Manchester Business Park, Aviator Way

Manchester City Council Comments – Applicant Response

Technical Note

Document Reference: 21347101-WAT-XX-XX-TN-N-800001_P01.01

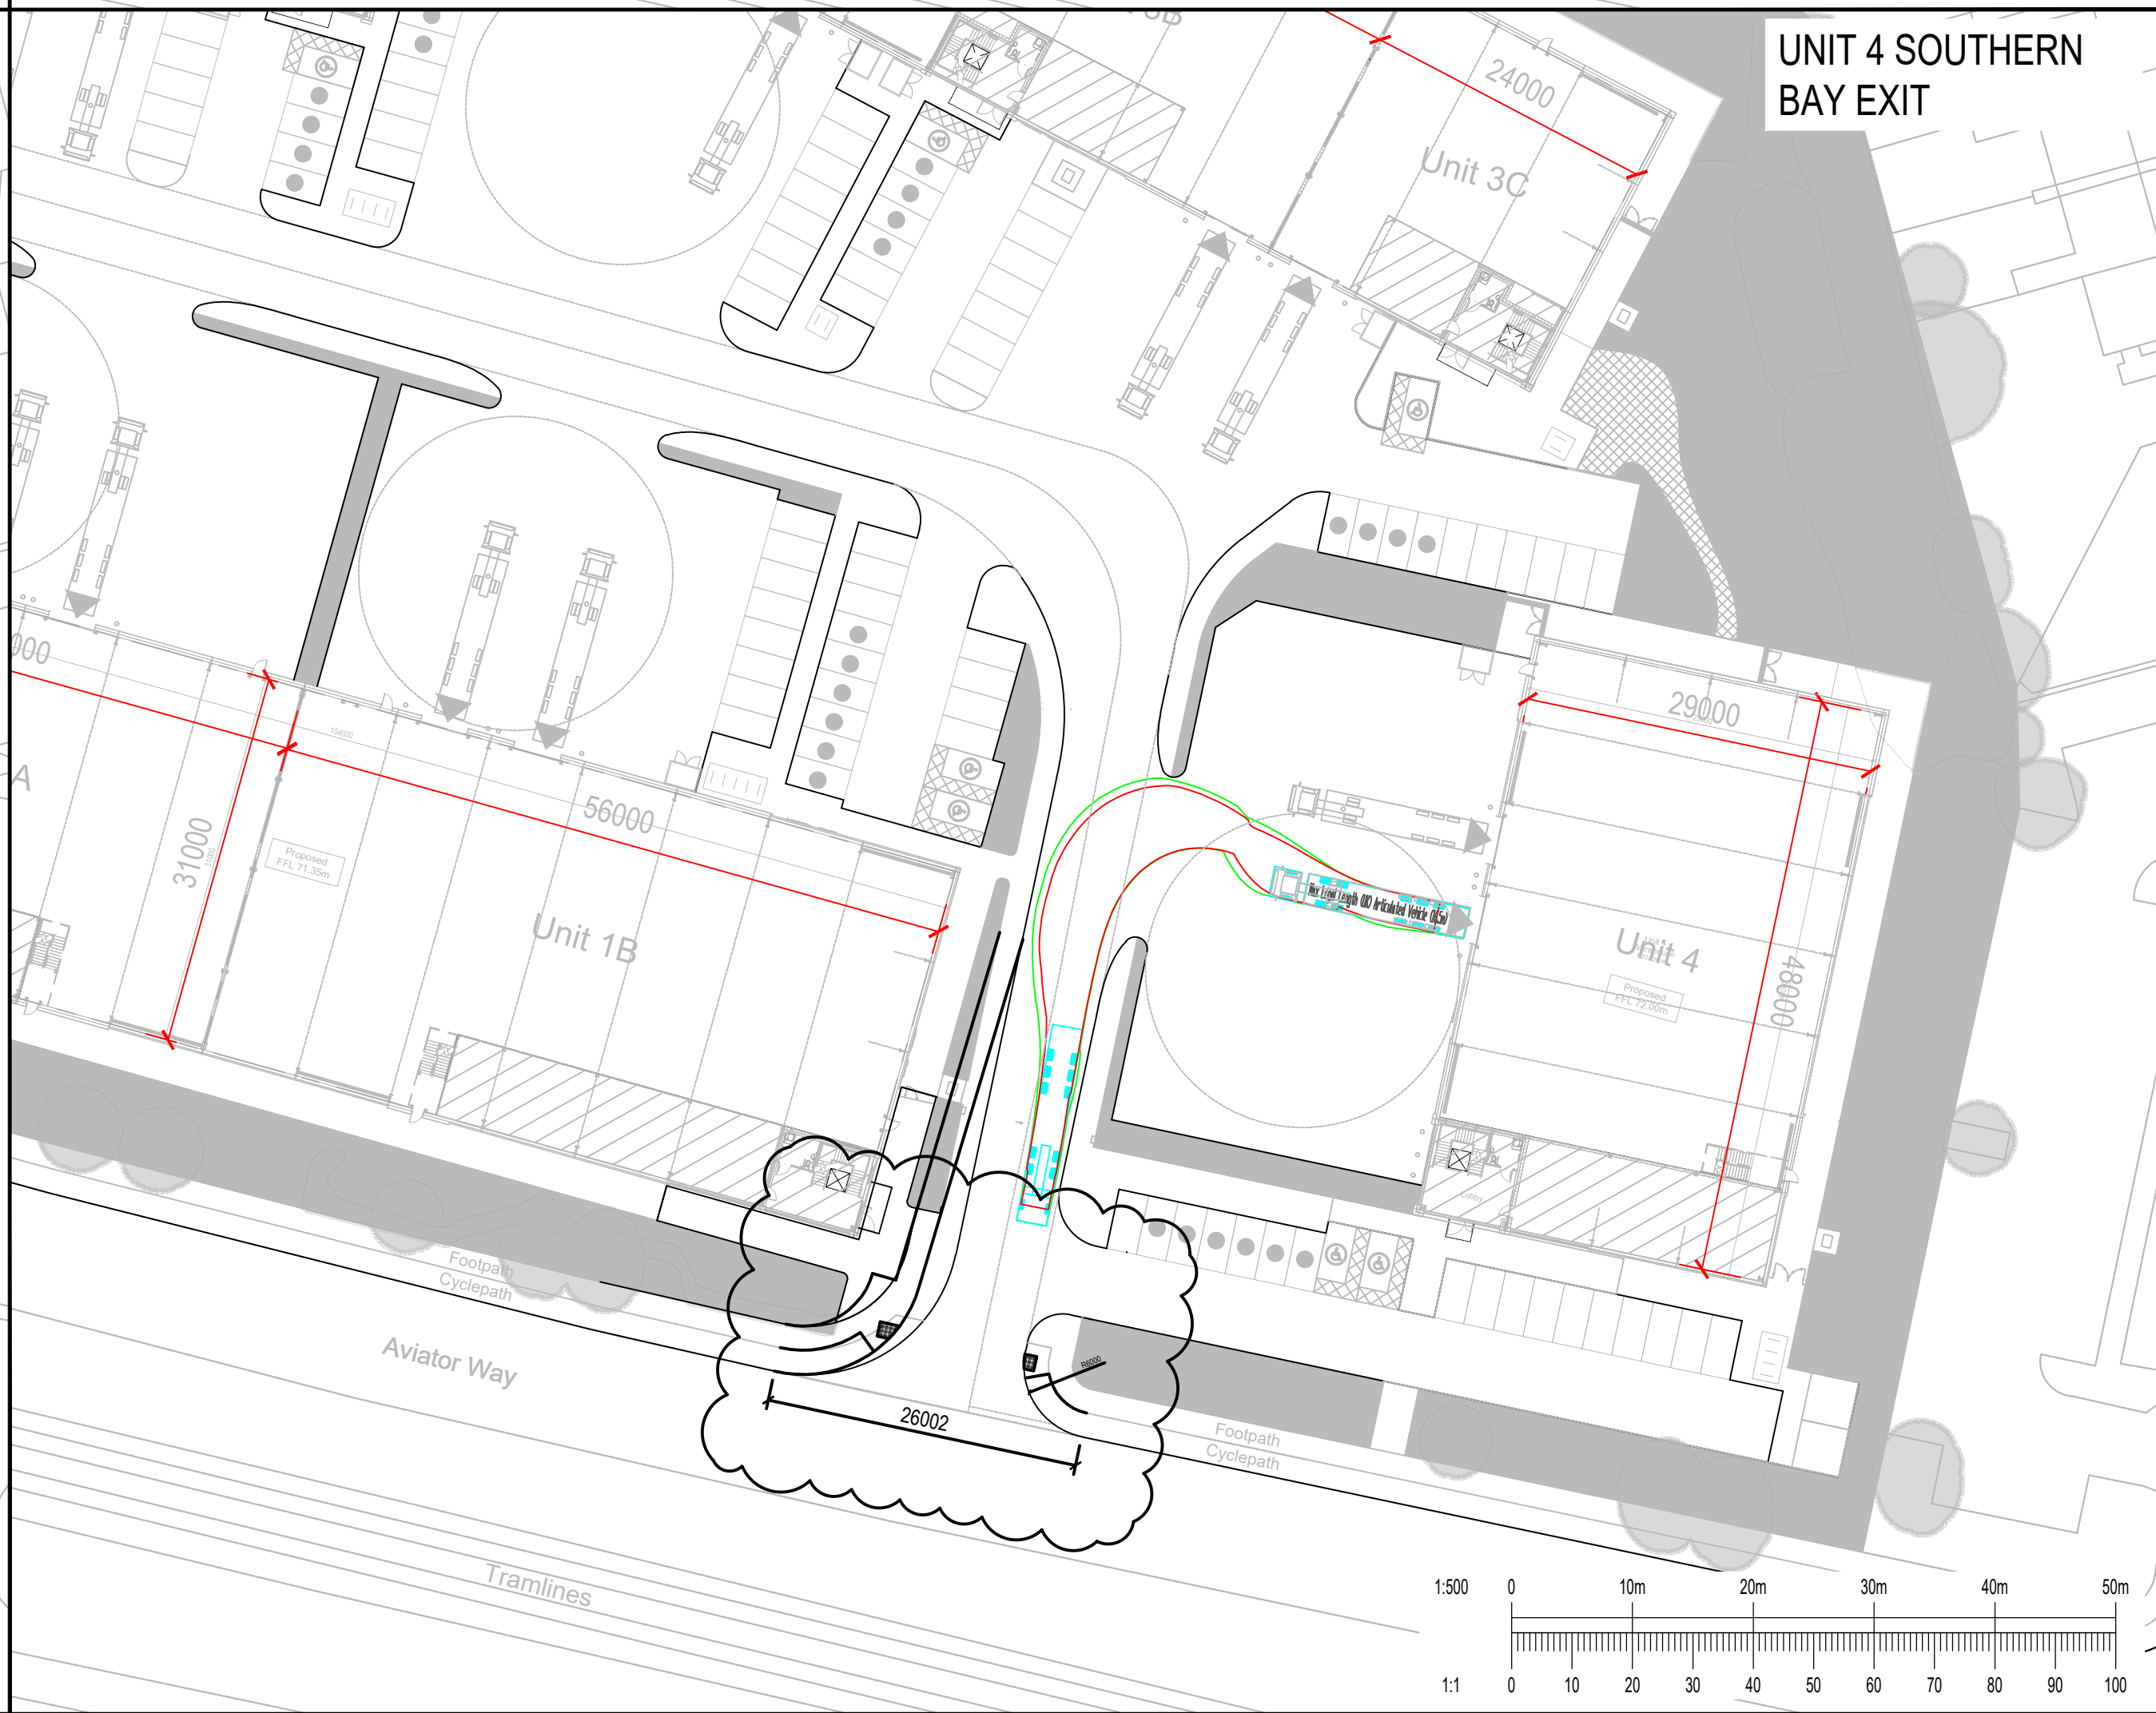
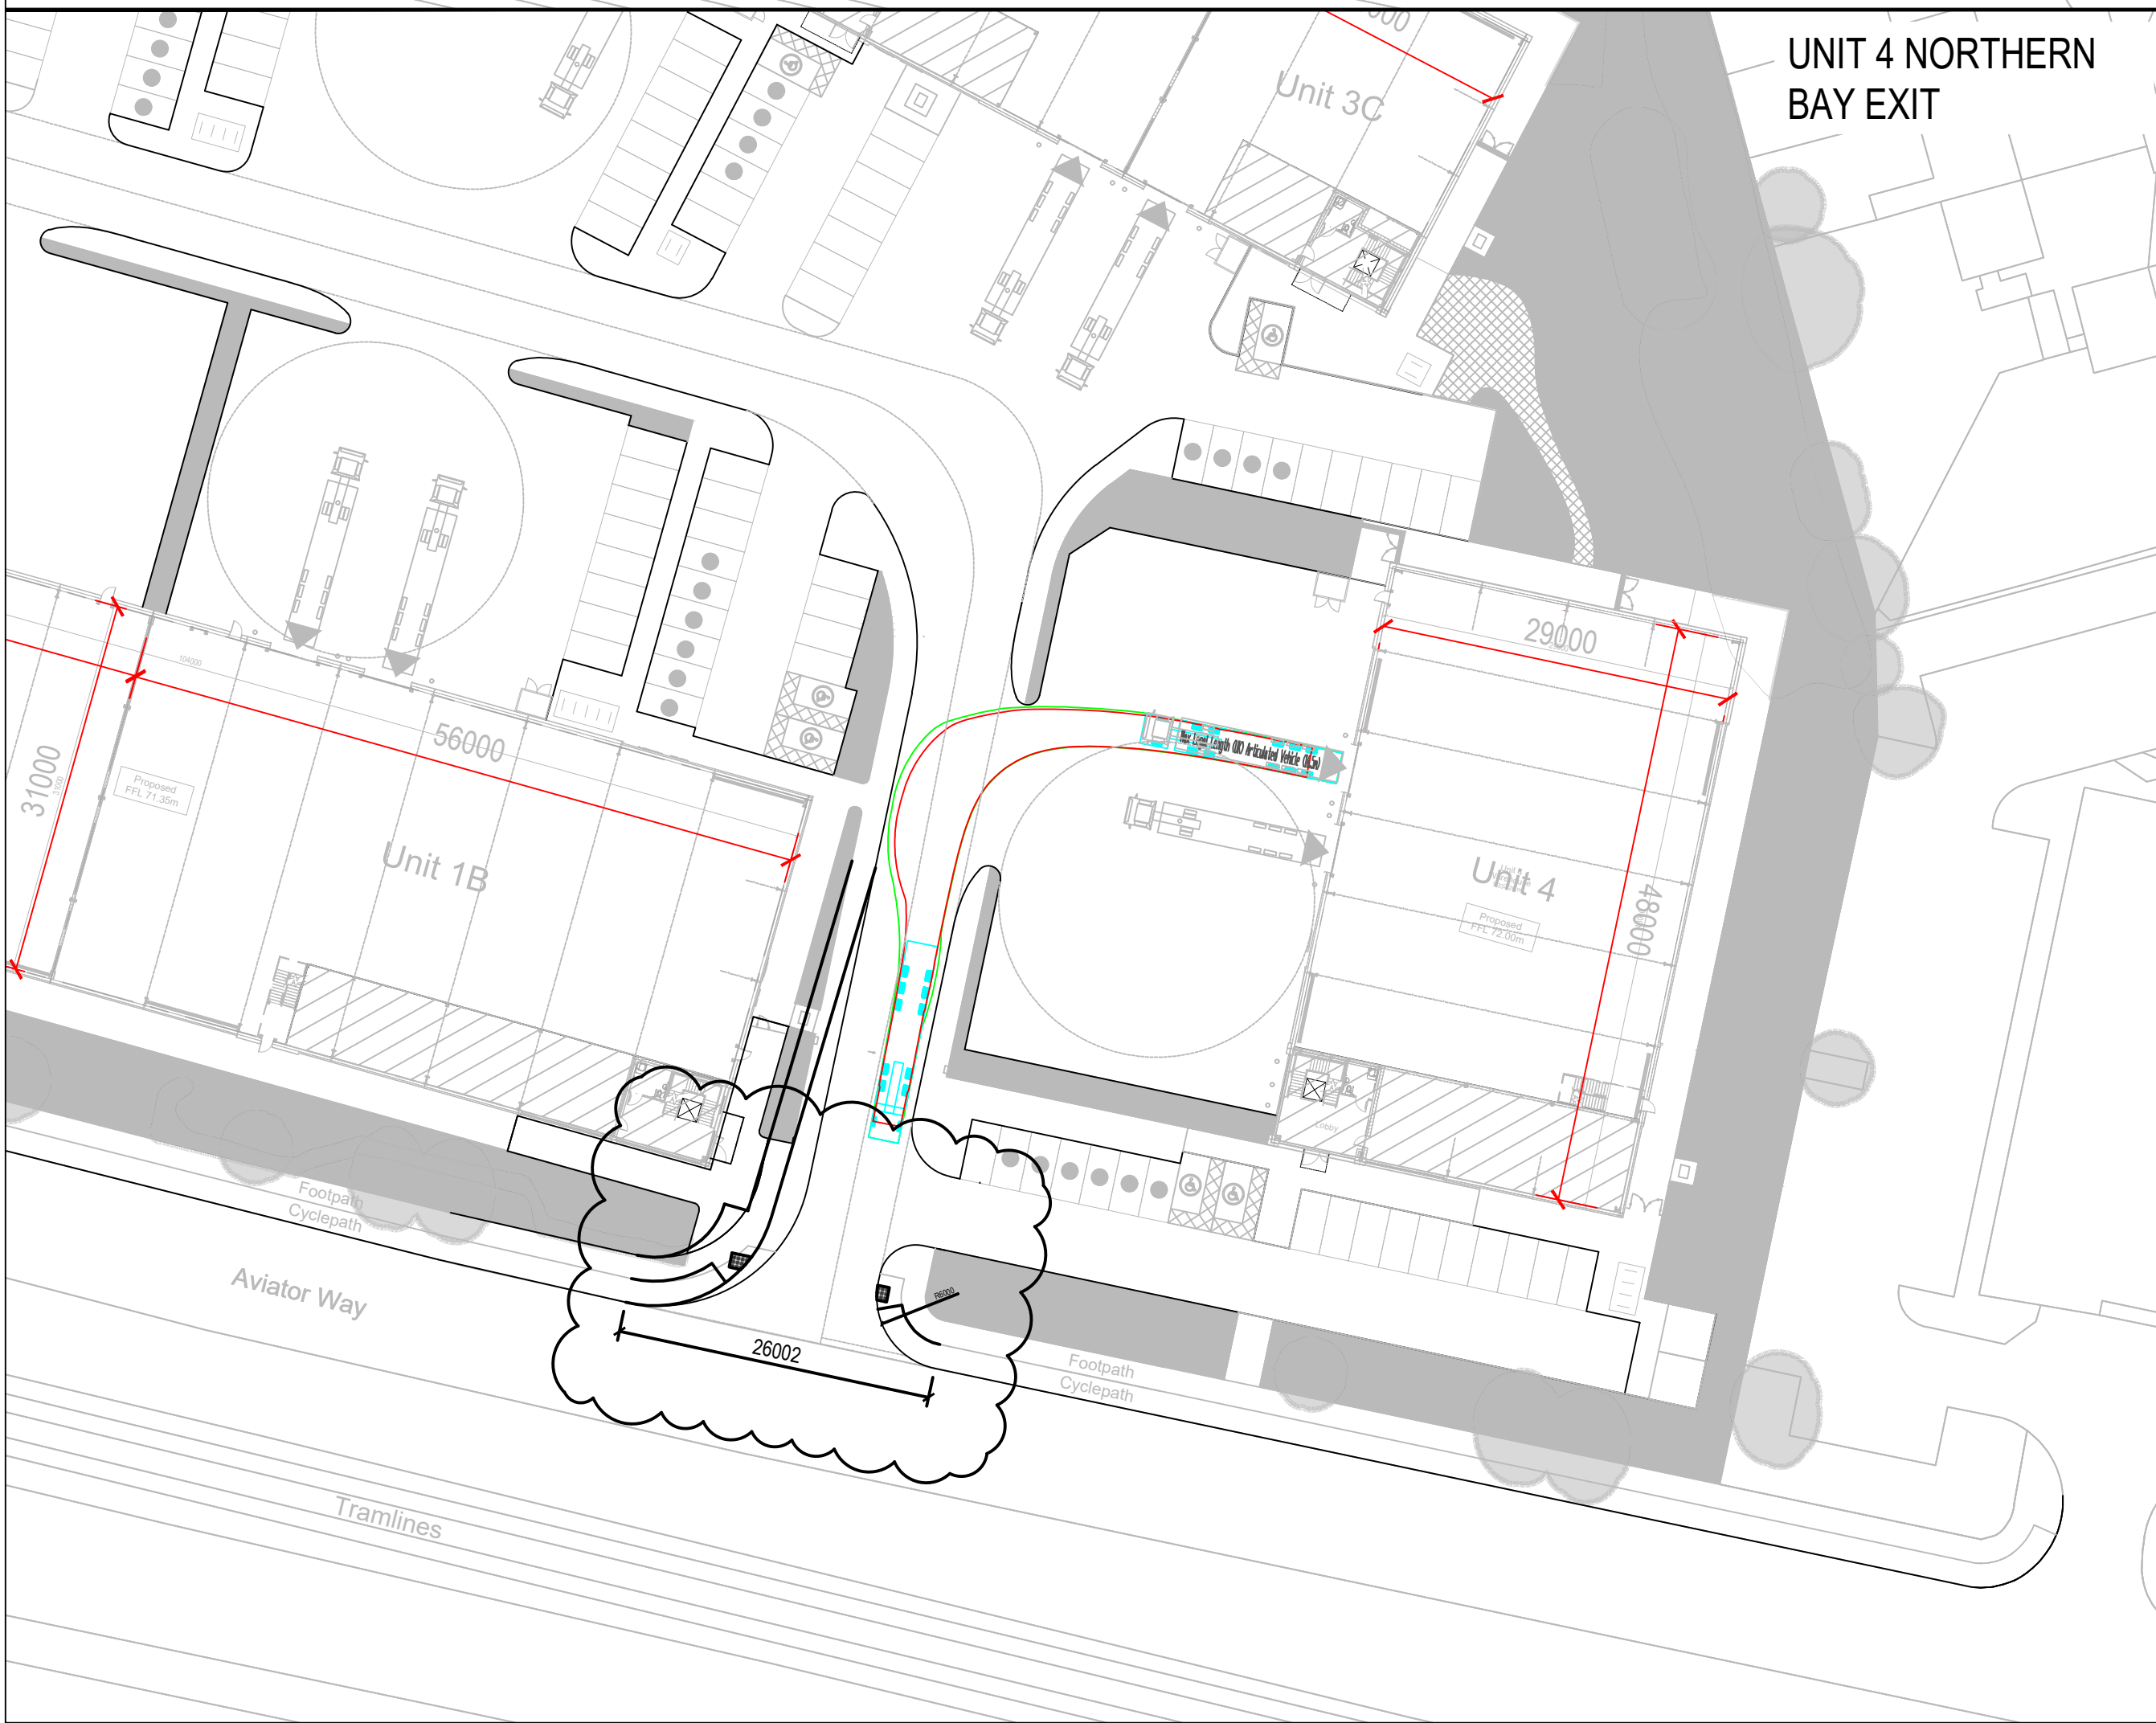
Requested that a TRICS based car parking accumulation assessment is undertaken with regards to the worst-case B2/B8 development scenario. Confirmation is sought on car parking dimensions and aisle width. This should be shown on an updated dimensioned plan.

- 2.11. The proposed parking provision is based on the Manchester Local Plan Core Strategy Car Parking Standards and is policy compliant. A TRICS based parking accumulation exercise has been conducted for each Unit, based upon the trip generation forecasts presented within the submitted Transport Assessment, and the maximum occupancy and number of available spaces for the 'worst case' B2 land use is presented in [Table 1](#) below.

- 2.12. [Table 1](#) illustrates that ample parking capacity is provided to accommodate the forecast demand in the 'worst case' B2 land use scenario for each Unit. Parking demand will be monitored and managed through a vision-led approach and travel planning measures delivered as part of the supporting Travel Plan.
- 2.13. Car parking space dimensions proposed are standard 2.5m x 5.0m bays, served by minimum 6.0m aisle widths. Disabled parking bays are 3.6m x 6.0m, inclusive of the marked buffer area.
- 2.14. A dimensioned parking plan and full parking accumulation summary tables for B2 and B8 land uses are provided at [Appendix D](#).
